WJ 8617B and 8618B 10 KHz IF Bandwidth Upgrade

By: Stephen Pappin

This procedure focuses on the modification of 20 KHz IF Amplifier and FM Demodulator boards.

Figure 5-19. Type 724006 21.4 MHz IF Amplifier (A3A9-A3A13), Location of Components

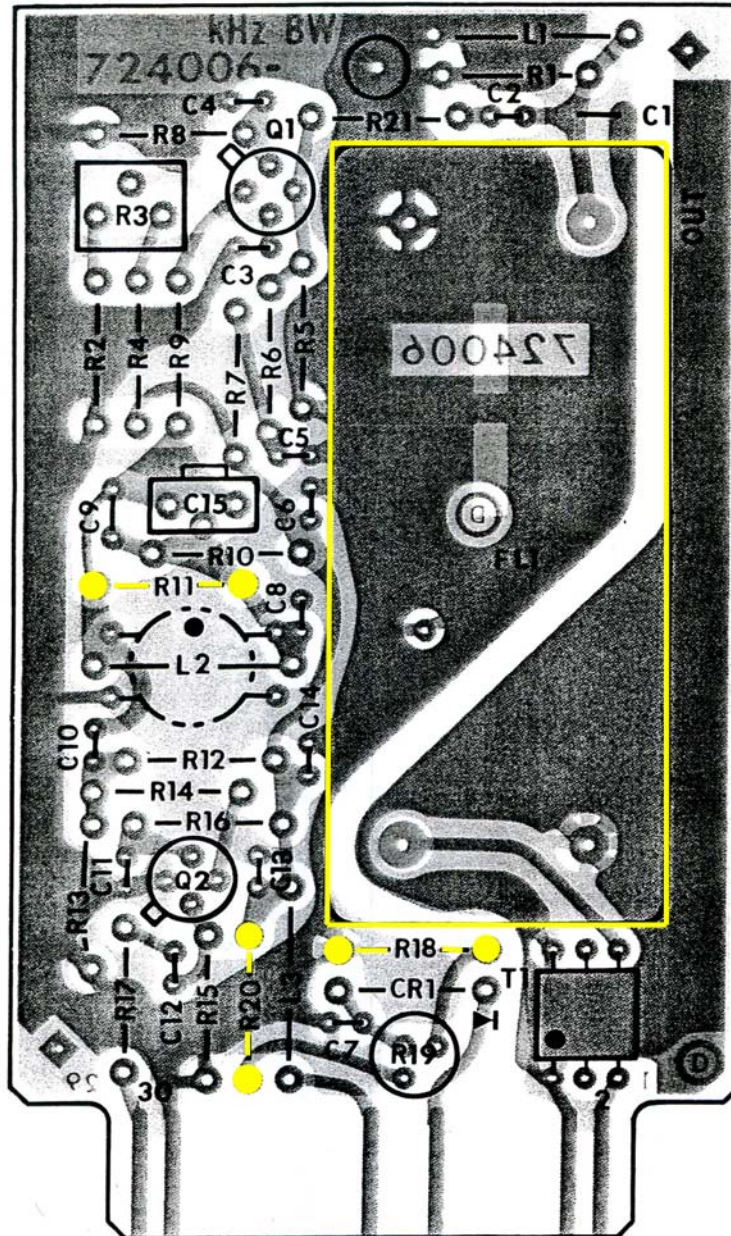
a. 724006-2, 20 KHz IF Amplifier board (A3A9 on page 4)

Remove R11

Replace R18 with a 100 Ohm resistor

Replace R20 with a 3.3K Ohm resistor

Replace the 20 KHz filter can p/n 92002 with the 10 KHz filter can p/n 92001

Change the board designation to -1

Figure 5-26. Type 794106 FM Demodulator (A3A17-A3A21), Location of Components

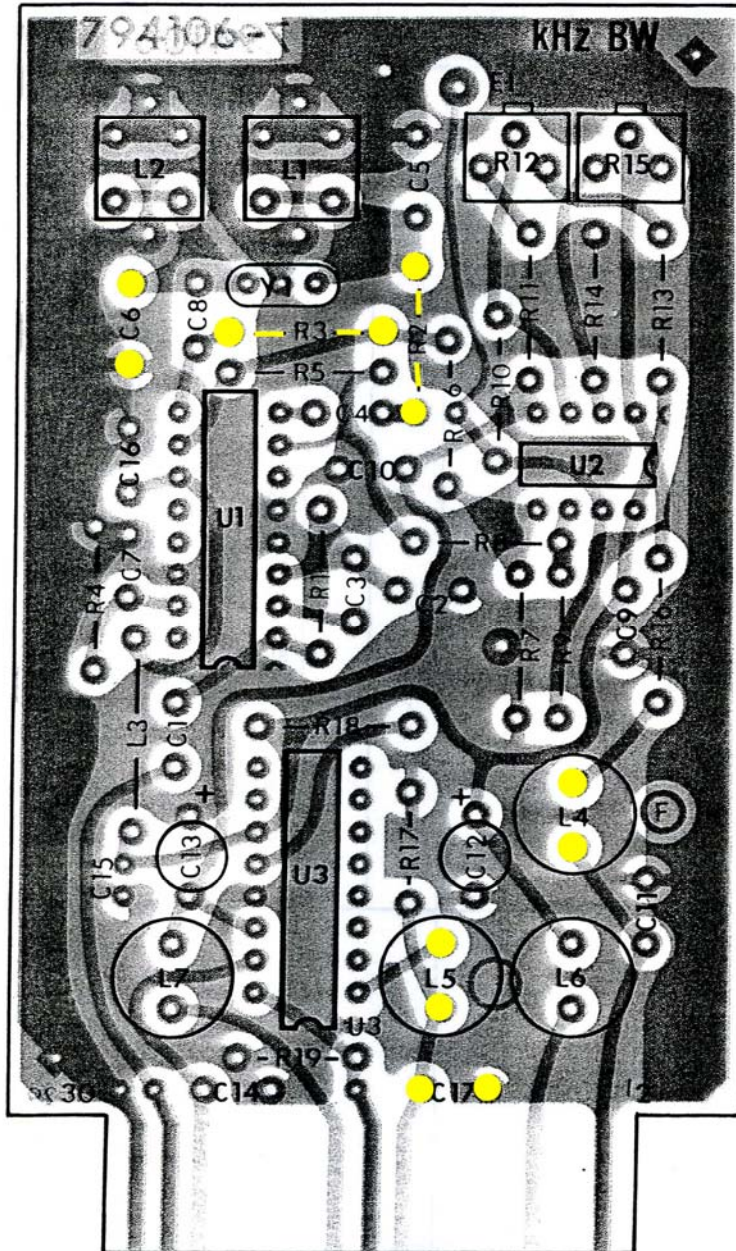
b. 794106-2, 20 KHz FM Demodulator board (A3A17 on page 5)

Replace L4 with a 22mH inductor

Replace L5 with a 15mH inductor

Replace C6 with a silver mica or ceramic capacitor

Replace C17 with a 0.068uF film or molded ceramic capacitor

Replace R2 with a 2.37K Ohm, 1/10 W, metal film resistor

Replace R3 with a 1.37K Ohm, 1/10 W, metal film resistor

Change the board designation to -1
